Plan Commission

Site Plan Review Case Summary

Proposal:	SP-26-001, Request approval to construct a 4,792 Sq. Ft. Kohler Credit Union located at the southeast corner of N. 18 th Avenue and W. Washington Street, by SVP Retail (Tax Key 1119-142-0127).
Council District:	2
Applicant:	SVP Retail
Existing Use:	Vacant land
Proposed Use:	Financial Institution
Land Use Plan Classification:	Commercial
Zoning Classification:	B-1 Community Business District
Lot Size:	4 acres
Staff Recommendation:	Approval with recommendations

SHEET TITLE:
SITE GRADING
PLAN

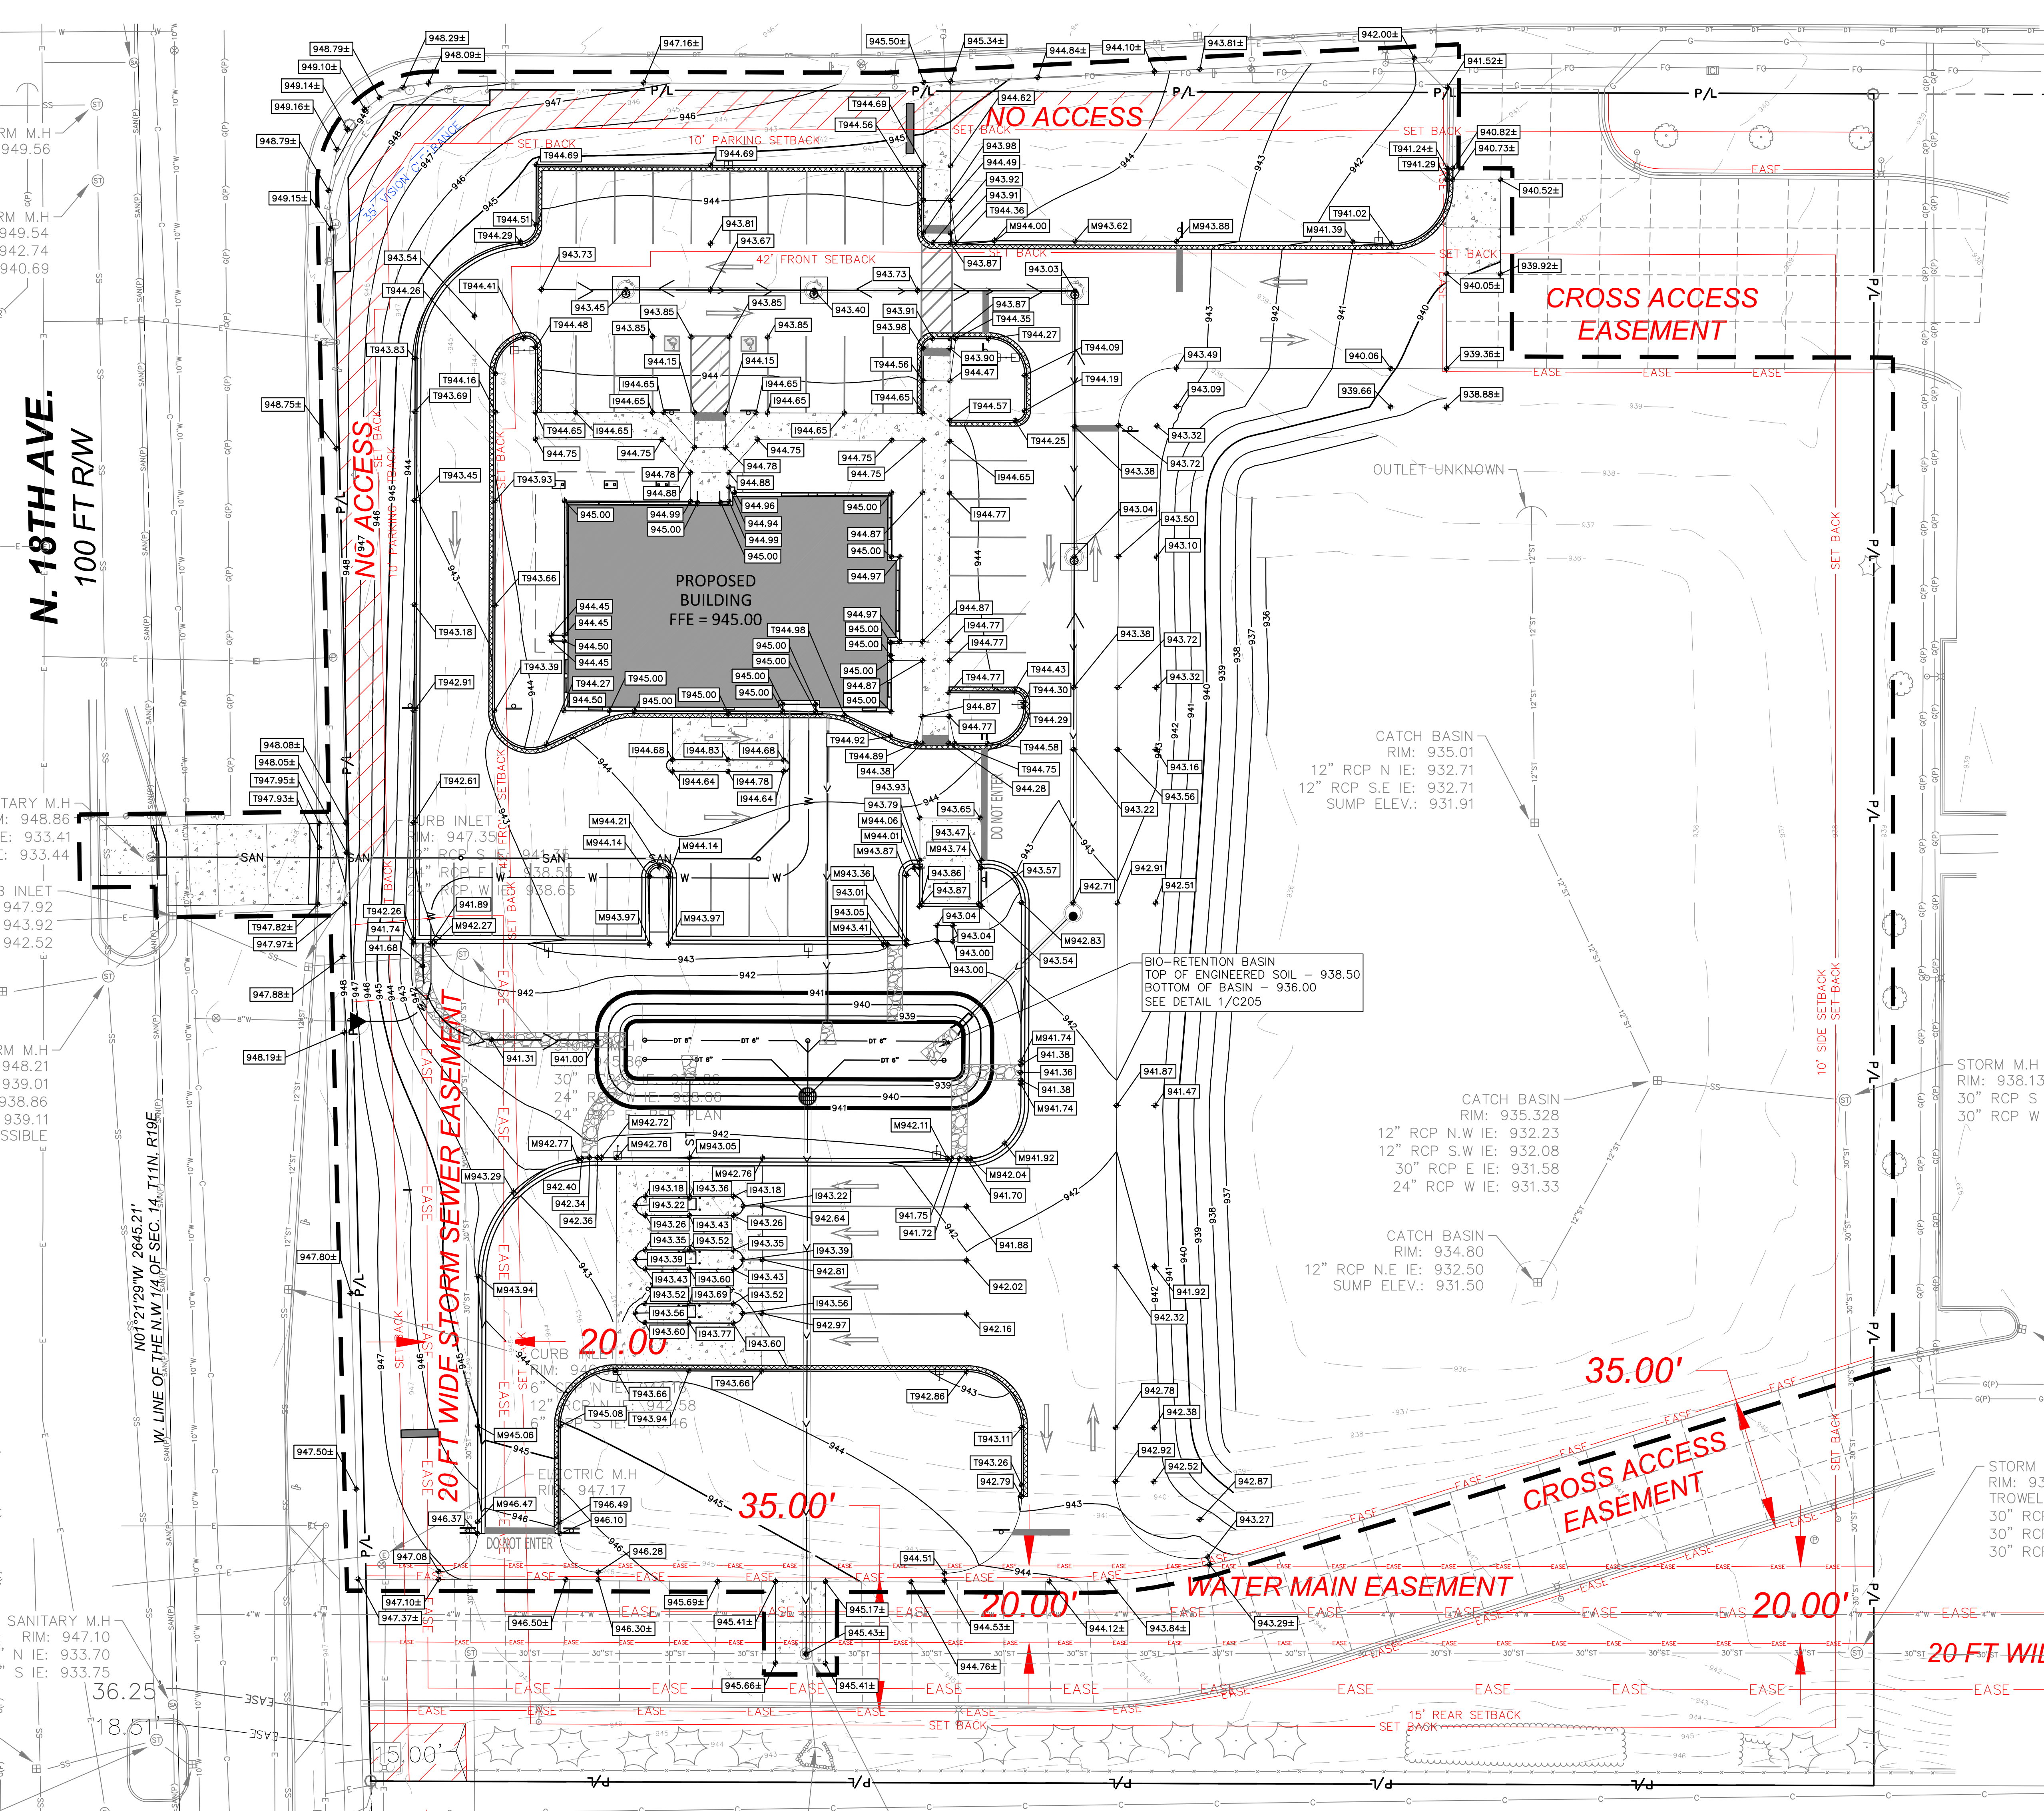
- A storm water management plan does exist for this area and the Engineering Department has been working with the developer on the submittal of a storm water management plan amendment. A

storm water management plan amendment will need to be submitted to and approved by the City Engineer prior to the issuance of a building permit.

- If any changes to the storm water plan require revisions, the site plan will need to be revised to be consistent with the storm water plan.
- The site grades have been designed to drain into the site to a storm water pond. The pond then drains into the existing storm sewer system that was installed at the time of the Kwik Trip development.

SHEET TITLE:
SITE LANDSCAPE PLAN

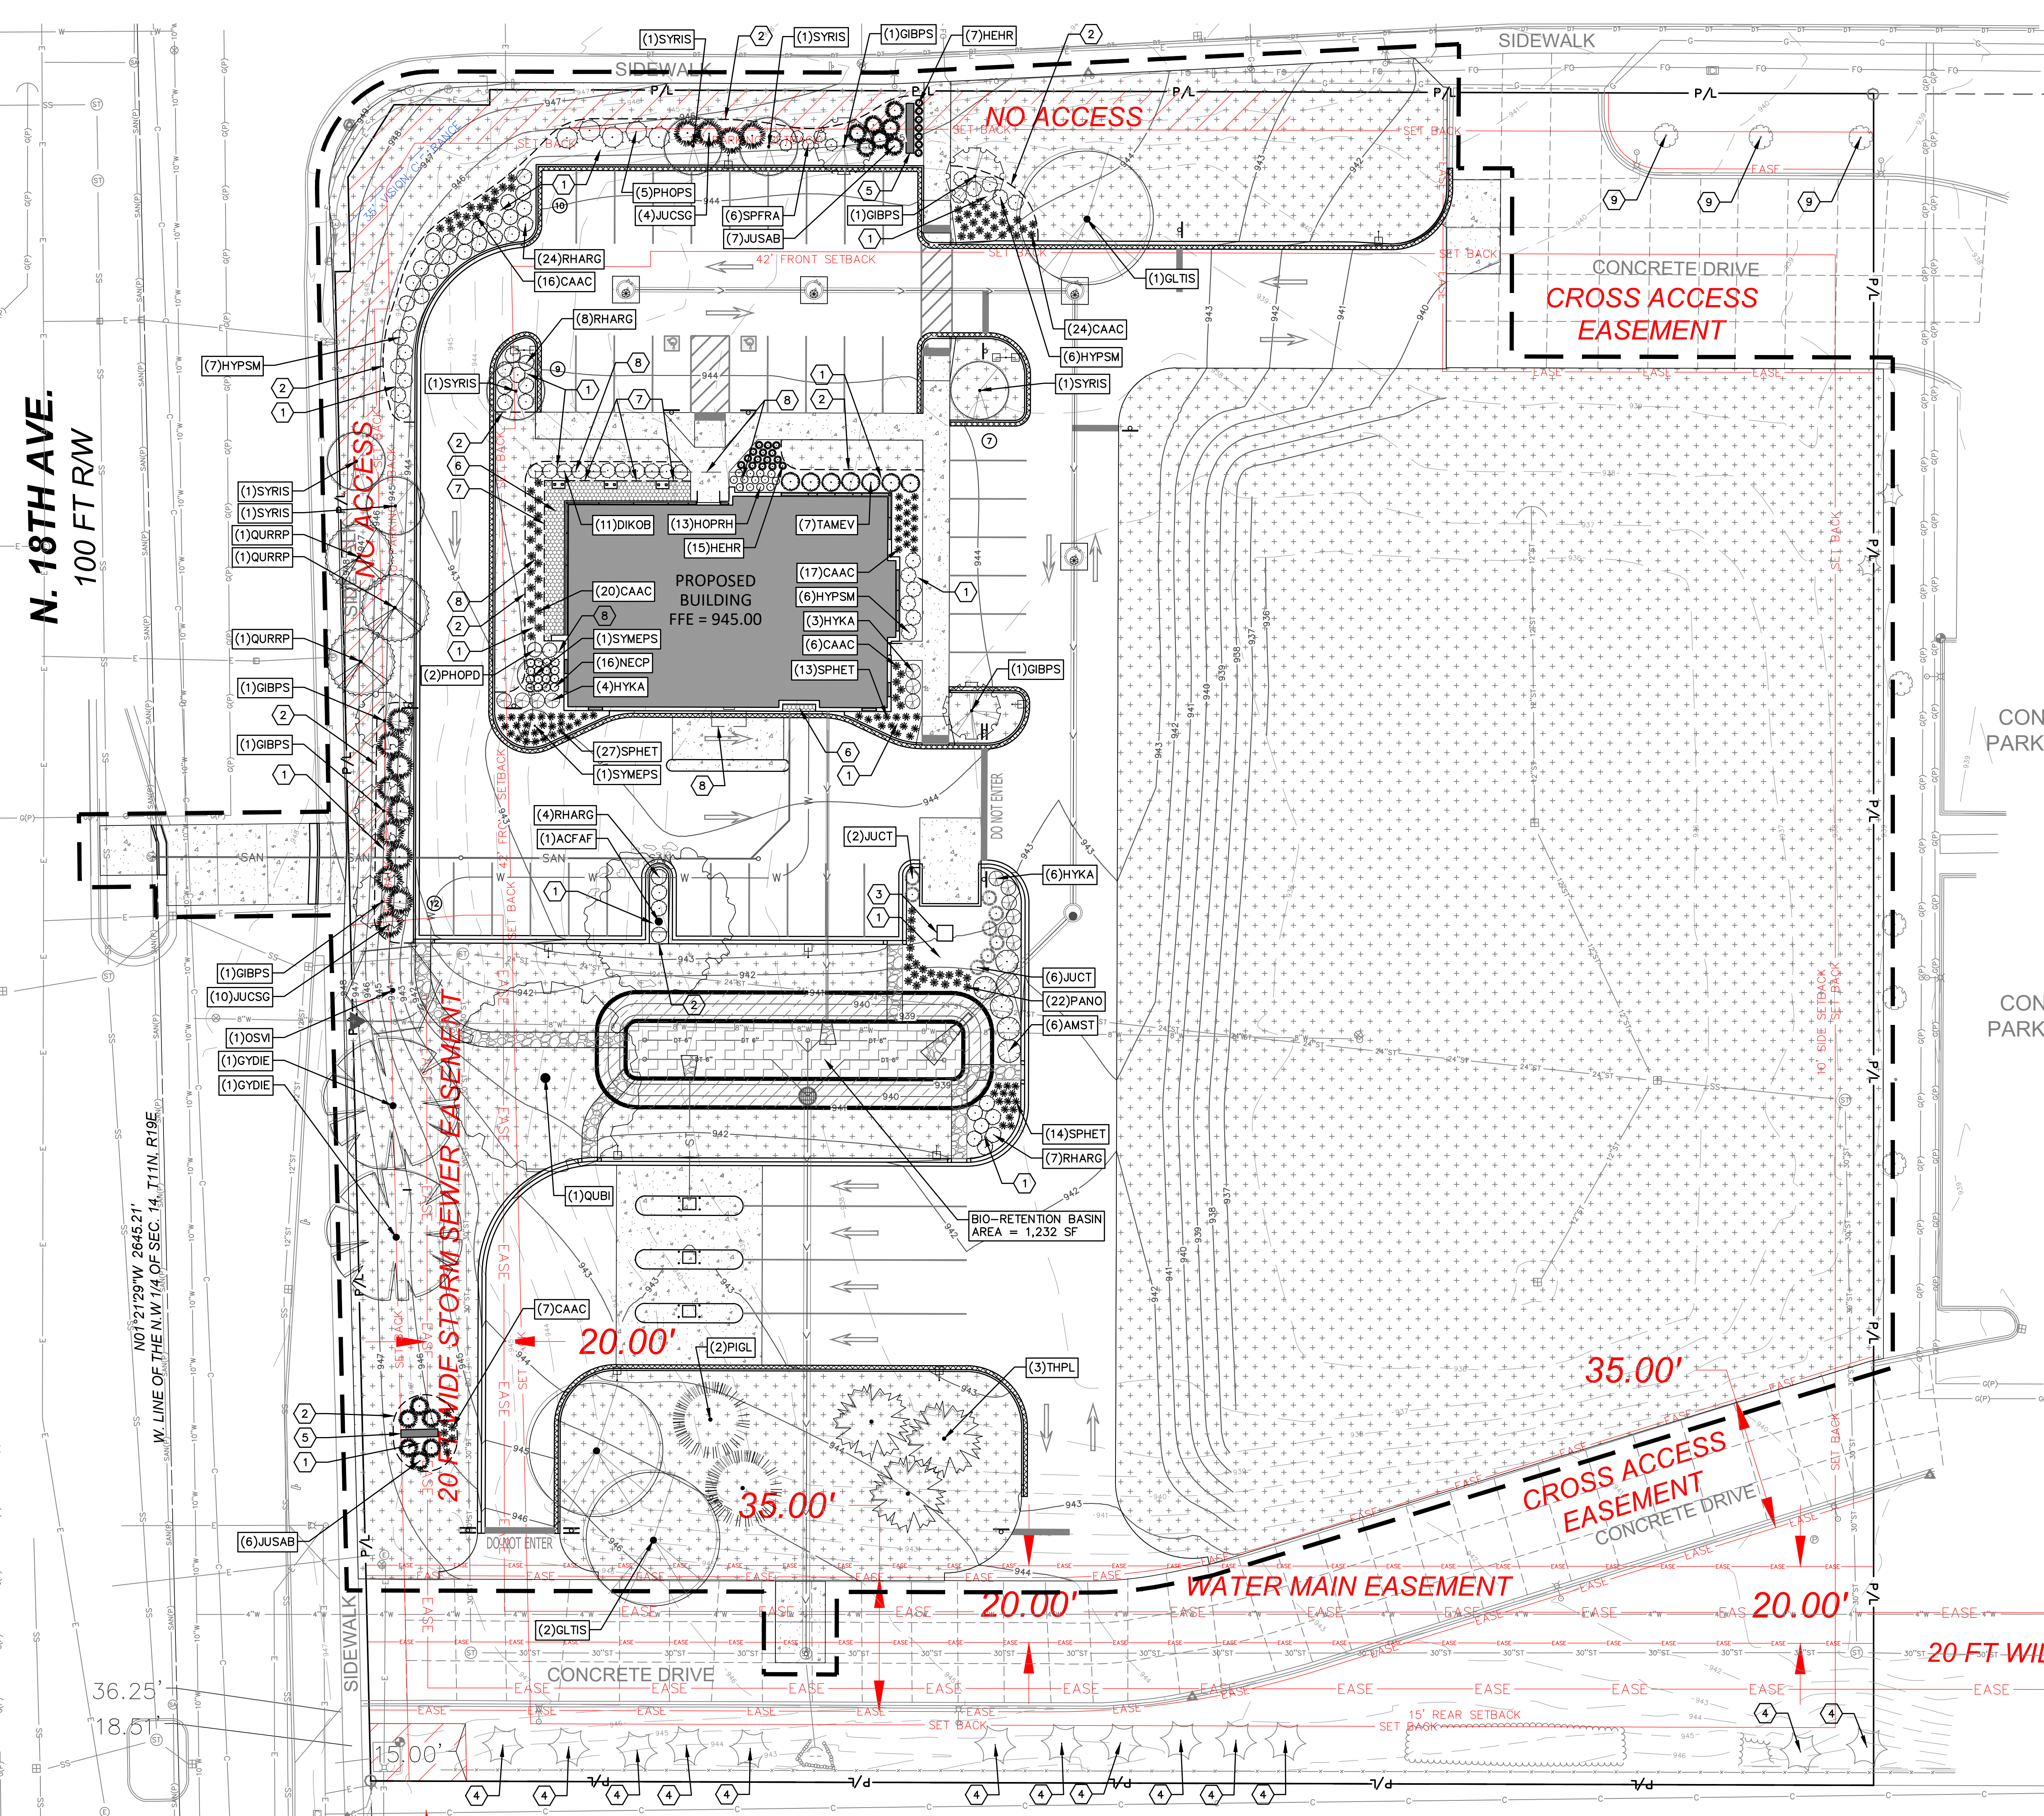
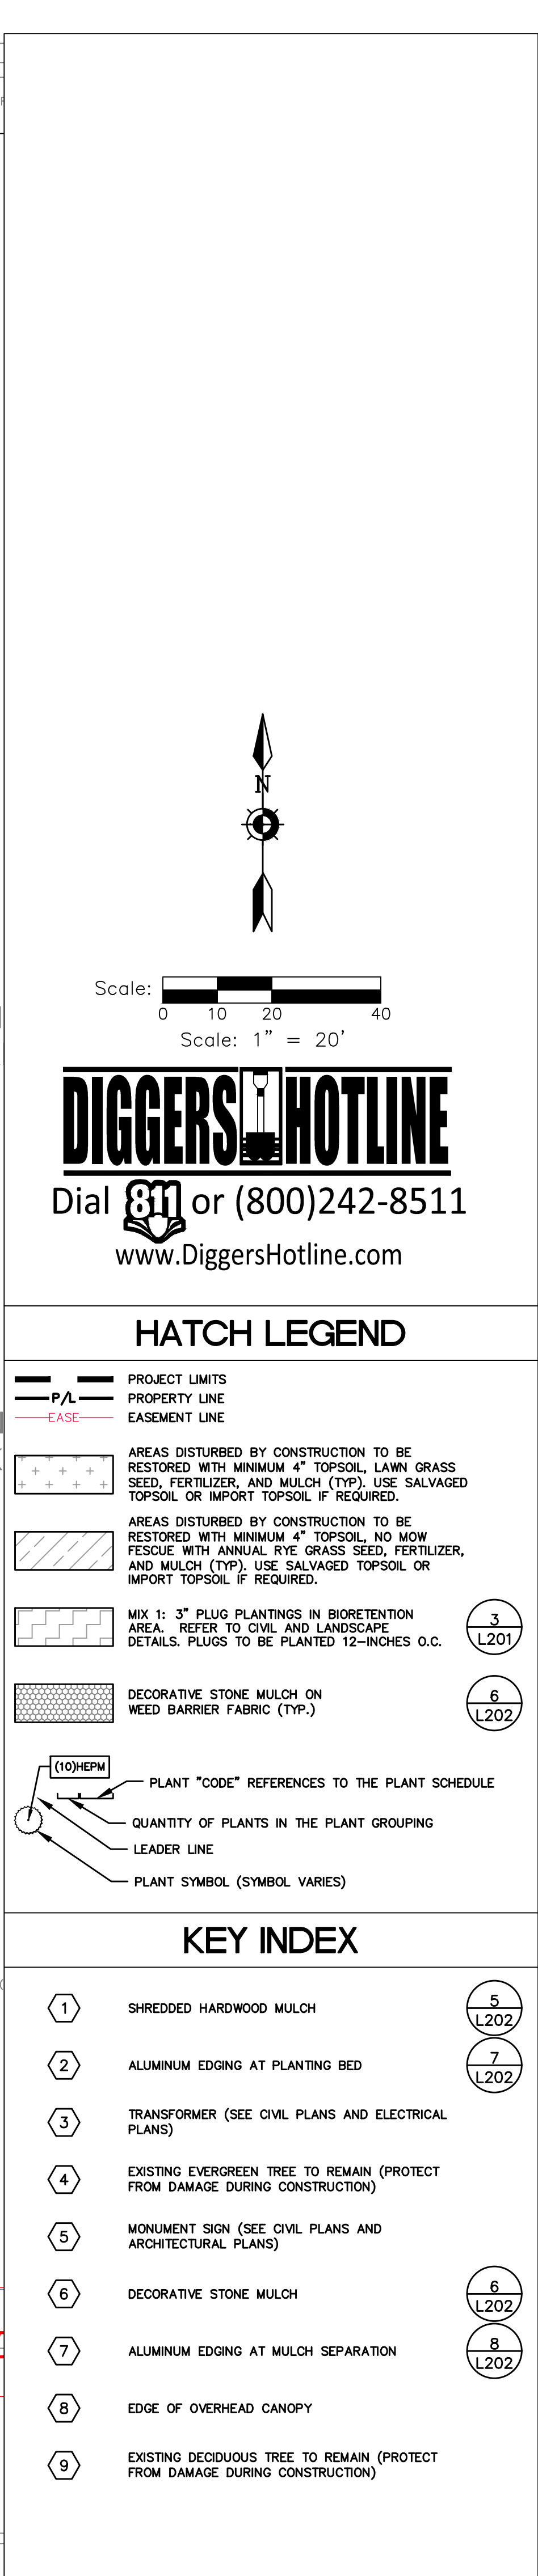
- The landscaping plan identifies foundation plantings along the north, west and east sides of the building. Parking lot landscaping and overall site perimeter landscaping has been provided. Minor landscaping revision will be needed at the northeast corner of the development.
- Snow Storage:
 - Snow Storage areas are provided in the green space areas and by the bio-retention basin.

SHEET TITLE:
EXTERIOR ELEVATIONS

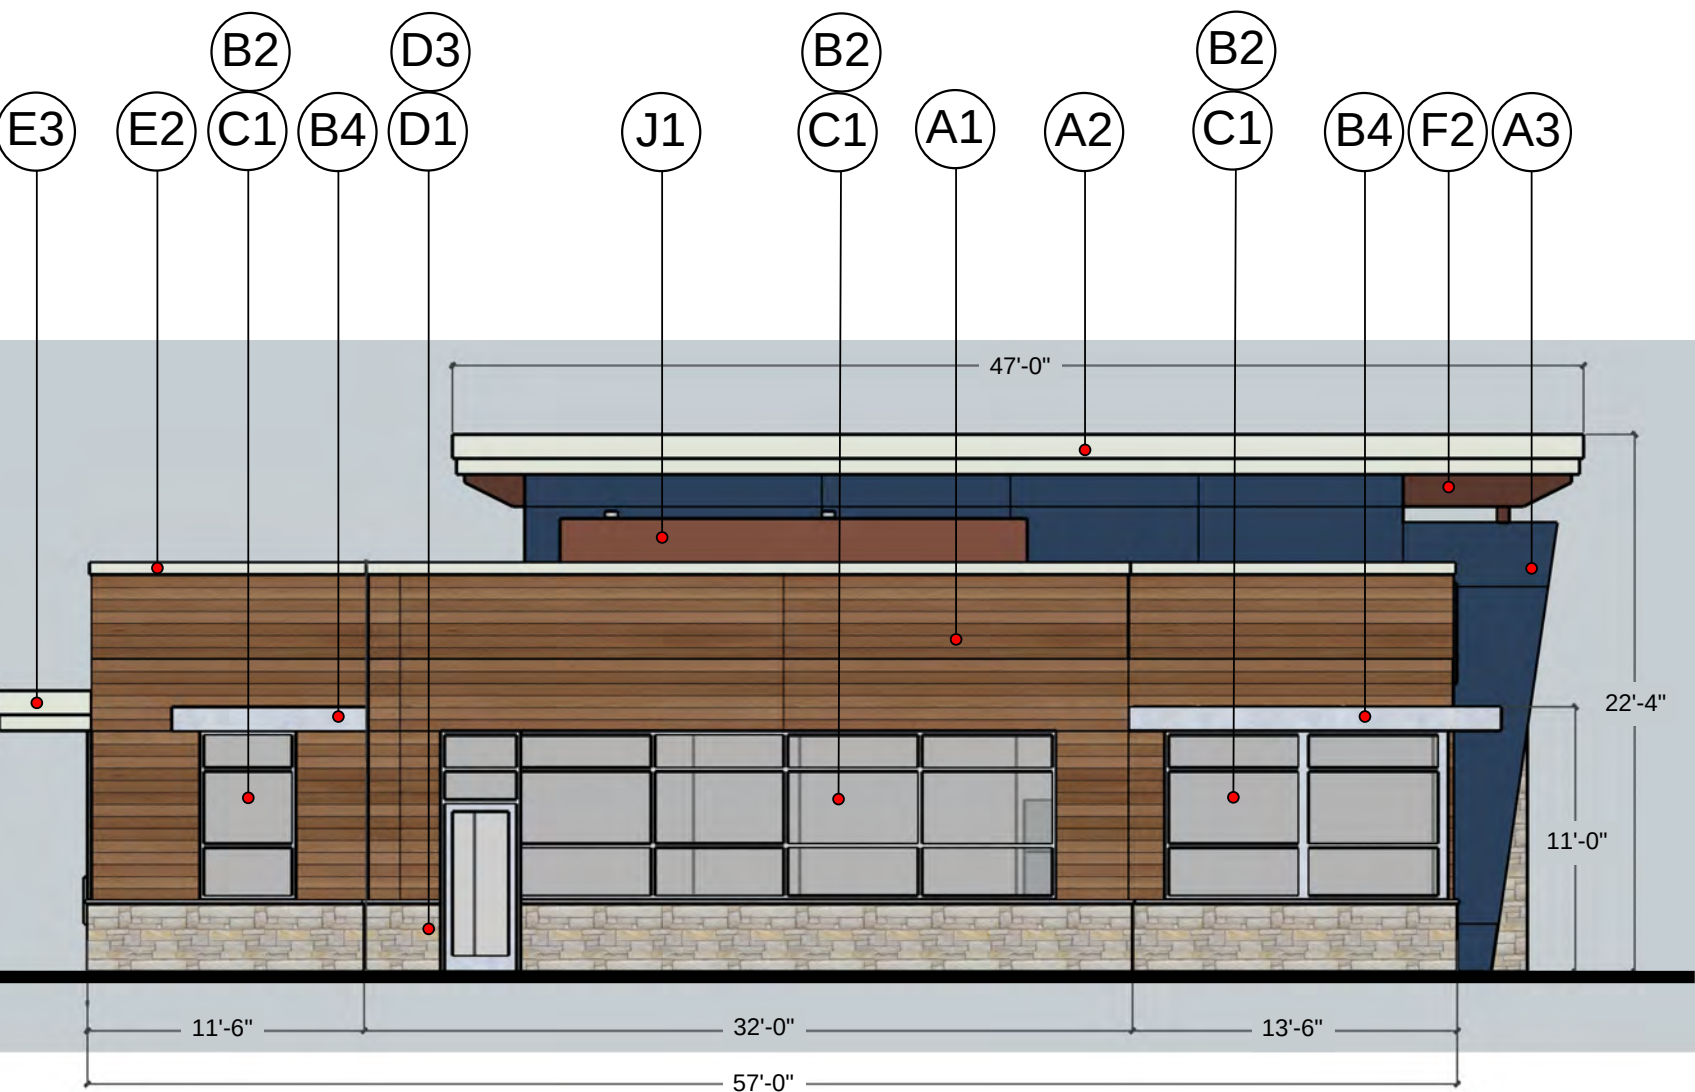
The submitted architectural elevations detail the proposed exterior building materials and color scheme. The building materials include a “Regal Blend” thin stone veneer along the lower portion of the building and all the building columns. “Dark Cherry” longboard Aluminum Cladding system will be used on the majority of upper portion of the walls. “AUB Blue” apolic metal panels will accent portions of the building and cover the columns of the canopy area.

The 16’x11’ dumpster enclosure will feature stained wood gates and the main surround will be constructed of the same “Regal Blend” thin stone veneer.
